Access Compliance Report

Public Rights-of-Way

(Curb Ramps)

Intersection ID: 45133	Main Street: SATTERFIELD_CT	Cross Street: LITTLE_WHITEOAK_RD	Location: NW
ADA ID: 6BACE89660C7	Ramp Type: Perp	Initial Pass/Fail: Fail	Overall Compliance: No
Severity Score: 10			
Codes/Mitigation Info/Possible Solution		Field Measurements/Component Compliance

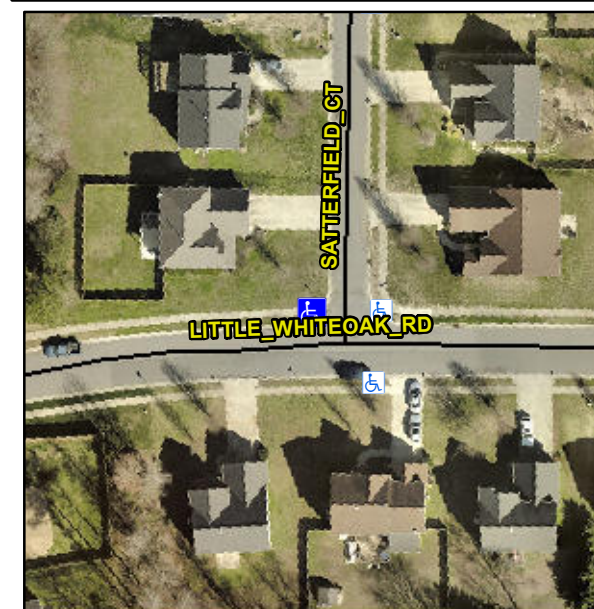
Not Found, R304.5.1, R304.5.3

Compliance	Description	Data	Compliance	Description	Data
N/A	Ramp Length (in)	51.0	Yes	Ramp Slope (%)	7.5
No	Ramp Width (in)	37.5	No	Ramp XSlope (%)	2.5
N/A	Flare Type LT	N/A	N/A	Flare Type RT	N/A
N/A	Flare Slope LT (%)	N/A	N/A	Flare Slope RT (%)	N/A
N/A	Flare Traversable LT?	N/A	N/A	Flare Traversable RT?	N/A
N/A	Landing Length (in)	N/A	N/A	DWS Provided?	N/A
N/A	Landing Width (in)	N/A	N/A	DWS Contrast?	N/A
N/A	Landing Slope (%)	N/A	N/A	DWS Length (in)	N/A
N/A	Landing X Slope (%)	N/A	N/A	DWS Full Width?	N/A
N/A	Landing Curb? (Y/N)	N/A	N/A	DWS Offset (in)	N/A
N/A	Shared Landing?	N/A			
N/A	Gutter Ponding?	N/A	N/A	Gutter Slope (%)	N/A
N/A	Gutter Lip Ht (in)	N/A	N/A	Gutter X Slope (%)	N/A
N/A	Painted X Walk1?	No	N/A	Painted X Walk2?	N/A
	X Walk 1 Direction	To E		X Walk 2 Direction	N/A
N/A	X Walk 1 Width (in)	N/A	N/A	X Walk 2 Width (in)	N/A
	X Walk 1 Slope (%)	0.2		X Walk 2 Slope (%)	N/A
	X Walk 1 X Slope (%)	1.2		X Walk 2 X Slope (%)	N/A

Remove & Replace Entire Ramp.
